FED. ROAD DIST. NO.	STATE	PROJ. NO.	FISCAL YEAR	SHEET NO.	TOTAL SHEETS
HAWAII	HAW.	3400A-01-07M	2007	ADD.18A	20

TRAFFIC SIGNAL PLAN

KAHULUI BEACH ROAD RESURFACING

Project No. 3400A-01-07M

AT WAIEHU BEACH ROAD

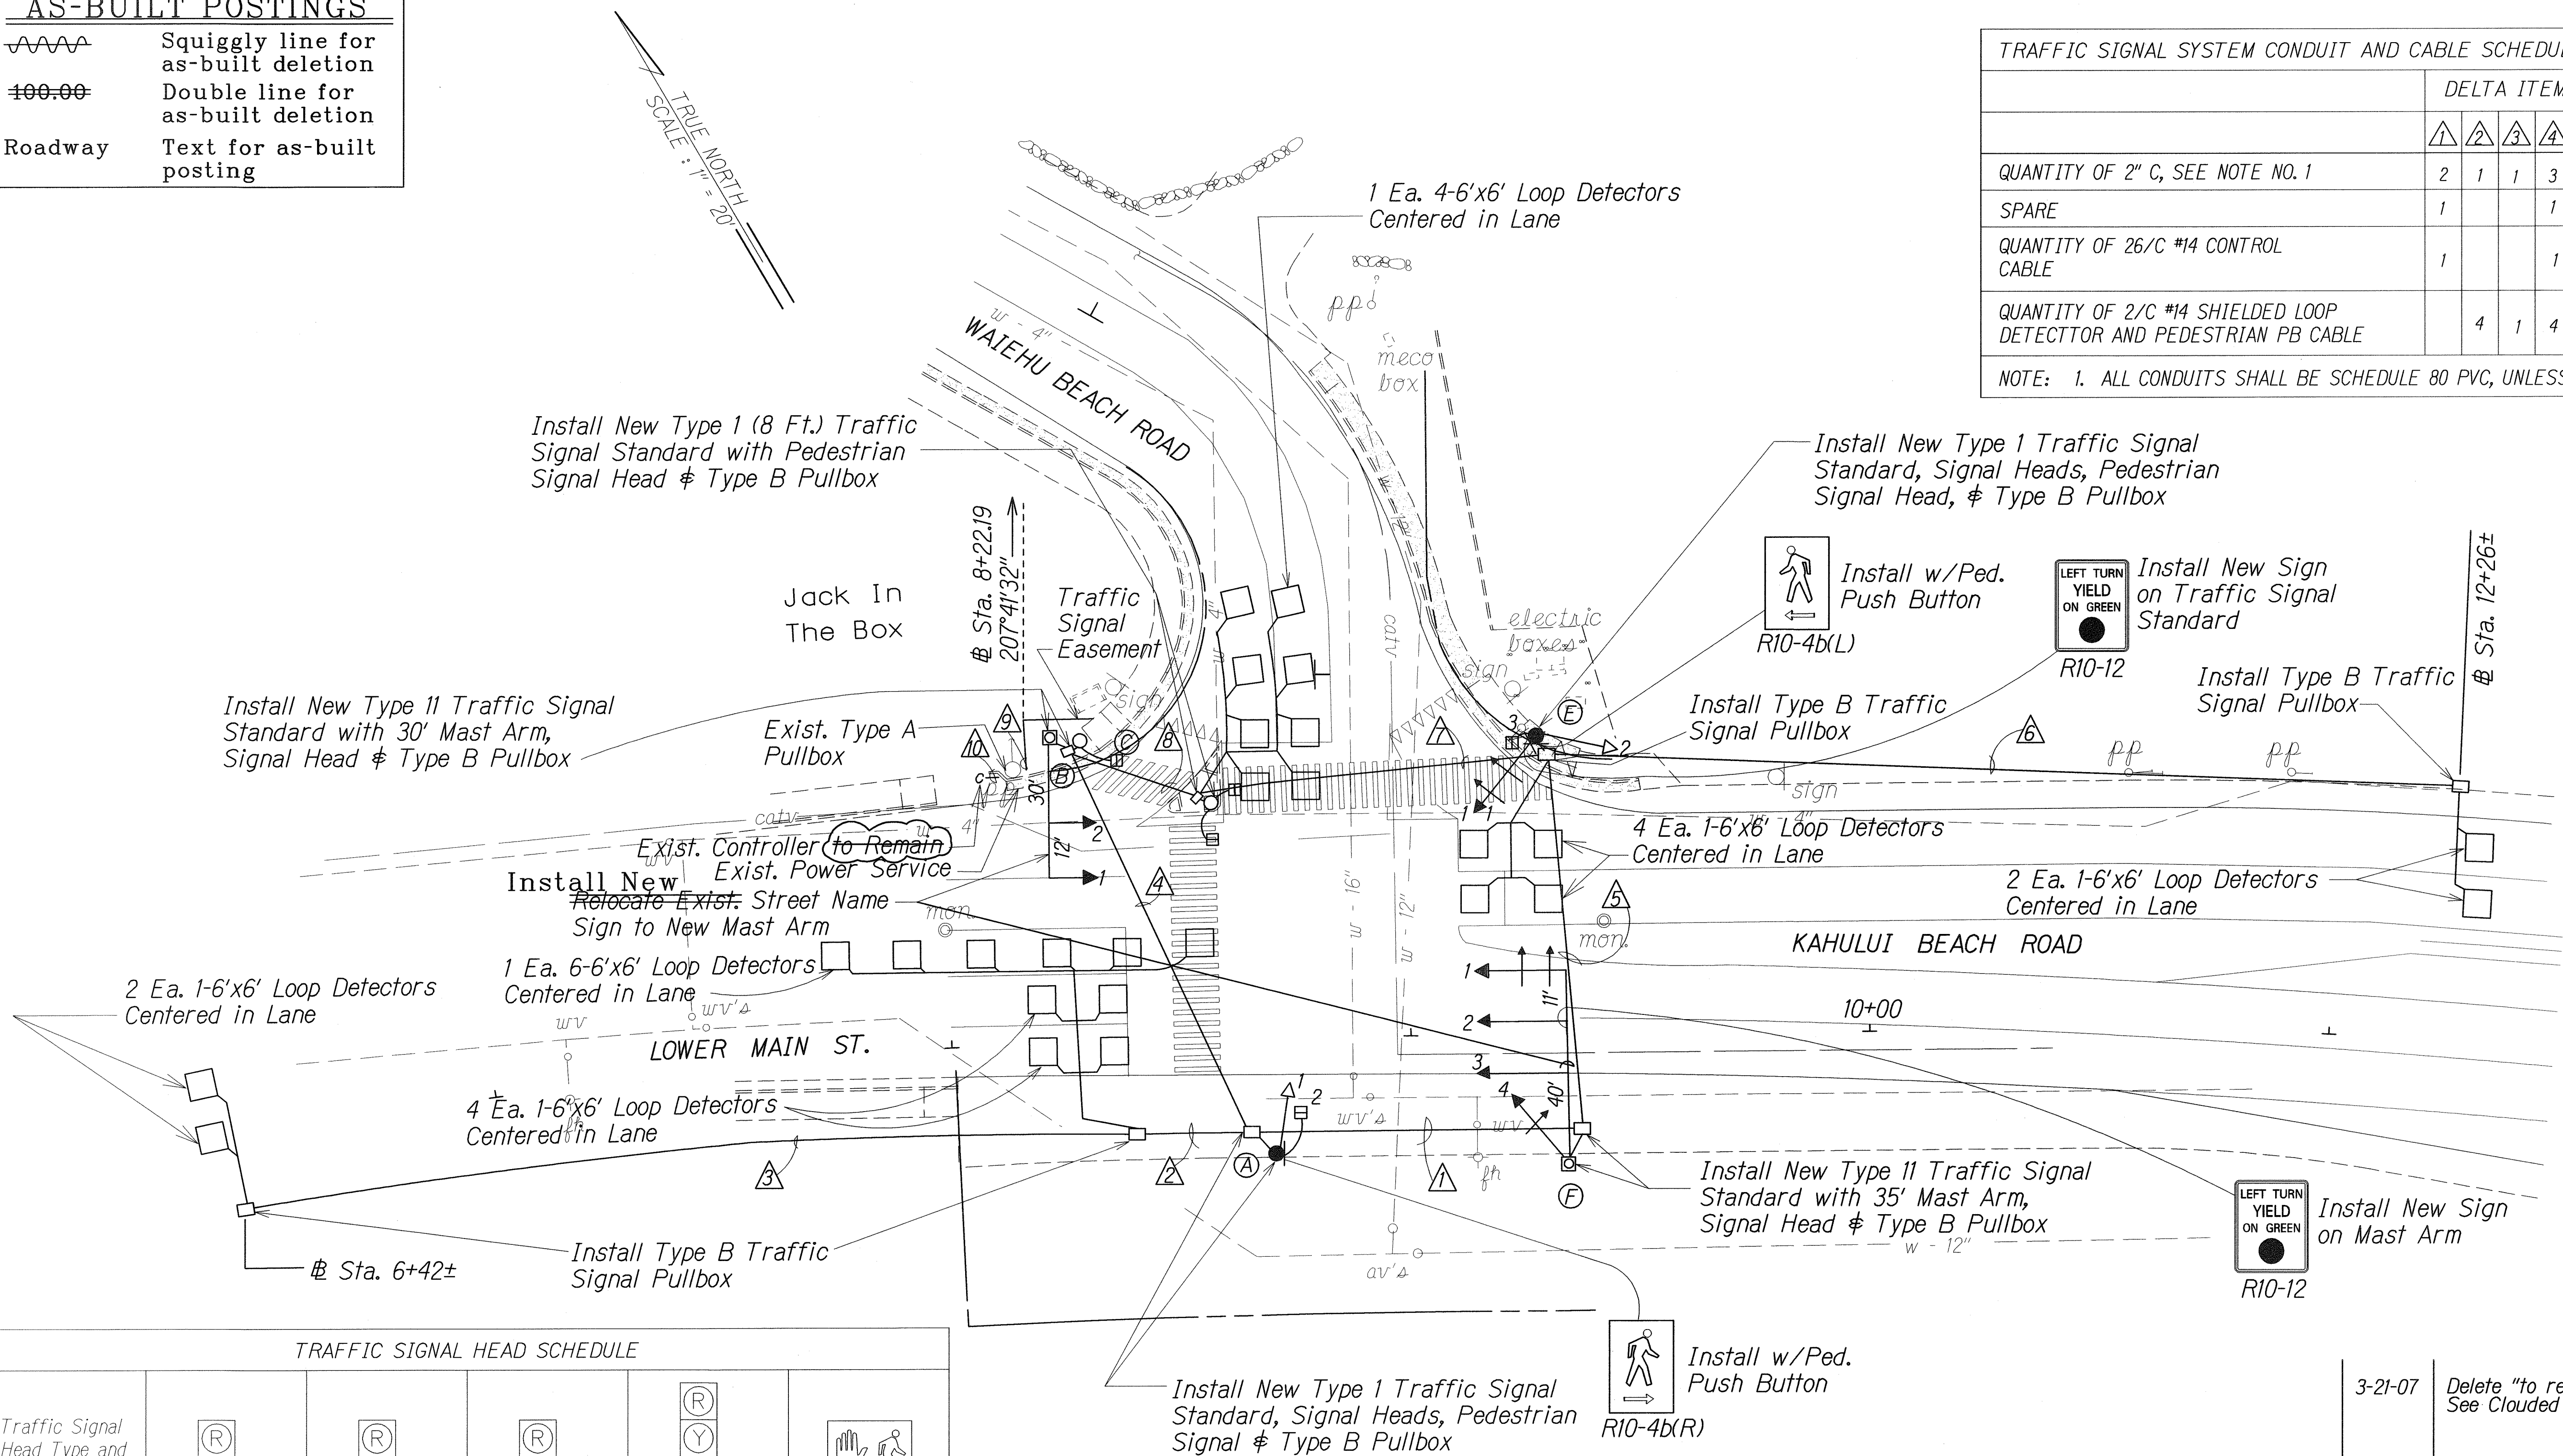
- NOTE:
- All Exist. Traffic Signal Standards, Mast Arms, Signal Heads and Appurtenances, Conductors & Loop Lead Cables, Controller and Cabinet shall be replaced. All work shall be Incidental to the Various Traffic Items.
 - The footings on Type II Traffic Signal Standard (B) shall be replaced. Footing and Signal Standard shall conform to current AASHTO 2005 Standards.

3-21-07	Delete "to remain". See Clouded Area & added Note #2.
---------	---

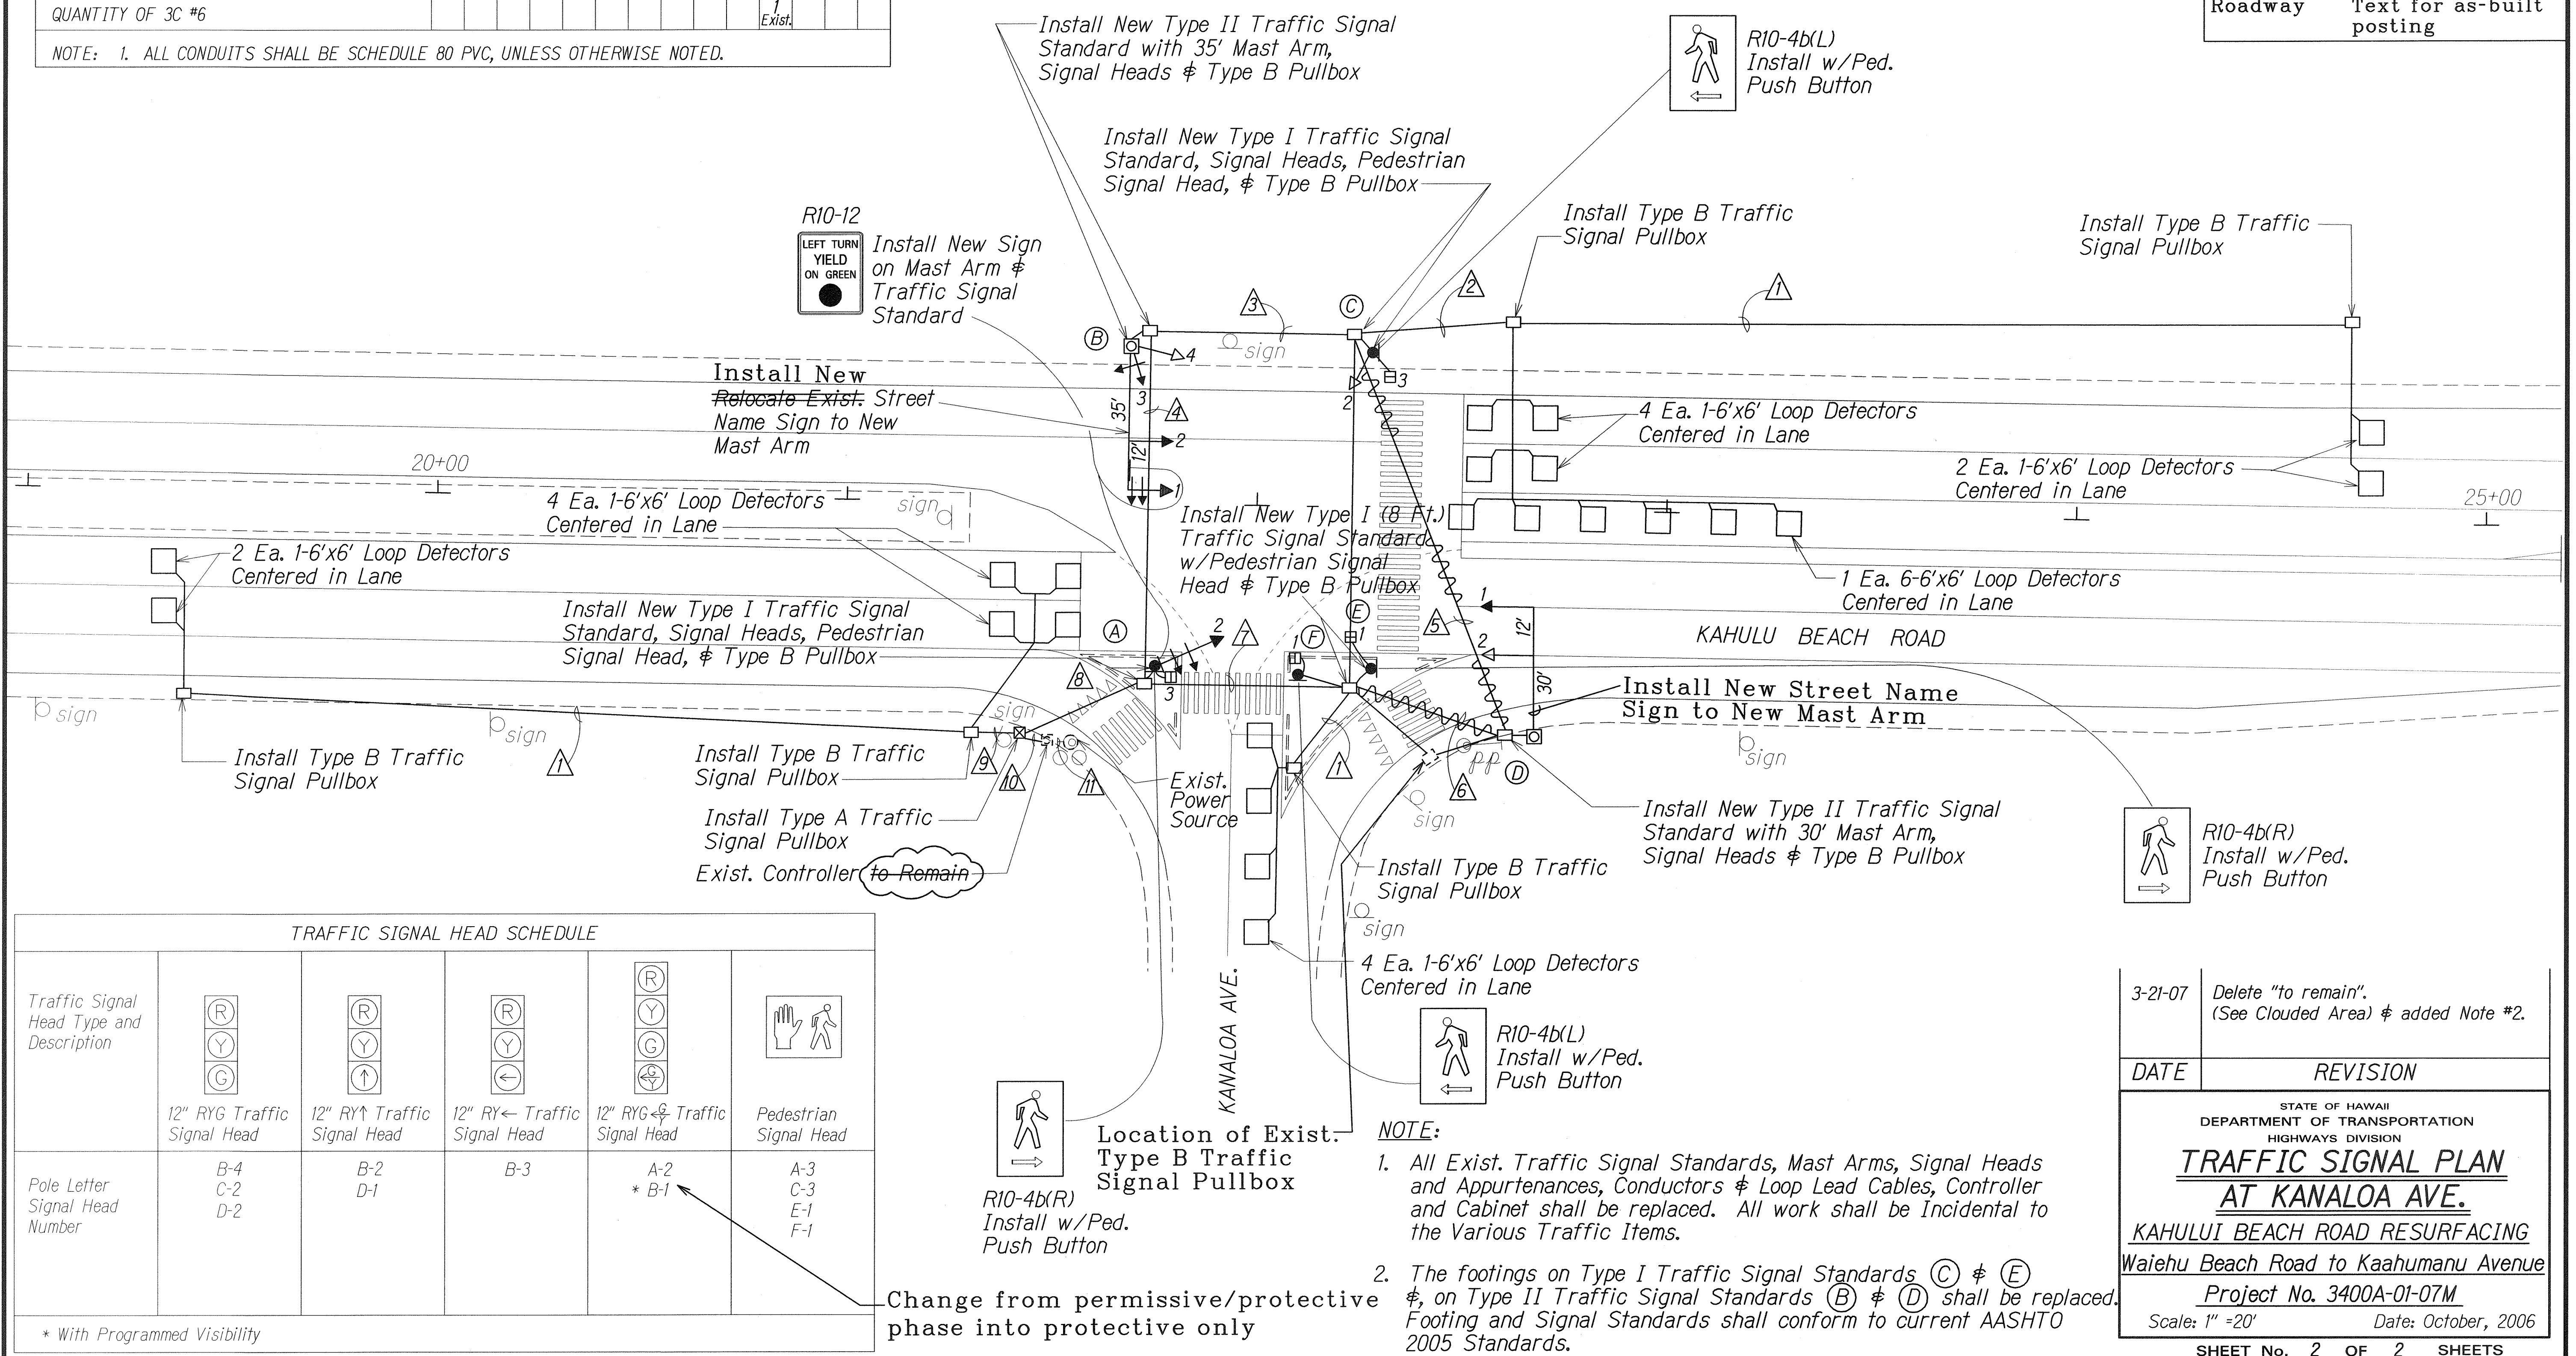
Additional Note:
The footings on Type I Traffic Signal Stds. (C) and (E) and on Type II Traffic Signal Stds. (B) and (D) shall be replaced. Footings and Signal Stds. shall conform to current AASHTO 2005 Stds.

3-21-07	Delete "to remain". (See Clouded Area) & added Note #2.
DATE	REVISION
STATE OF HAWAII DEPARTMENT OF TRANSPORTATION HIGHWAYS DIVISION TRAFFIC SIGNAL PLAN AT KAWALO AVE. KAHULUI BEACH ROAD RESURFACING Waiehu Beach Road to Kaahumanu Avenue Project No. 3400A-01-07M Scale: 1" = 20' Date: October, 2006 SHEET No. 2 OF 2 SHEETS
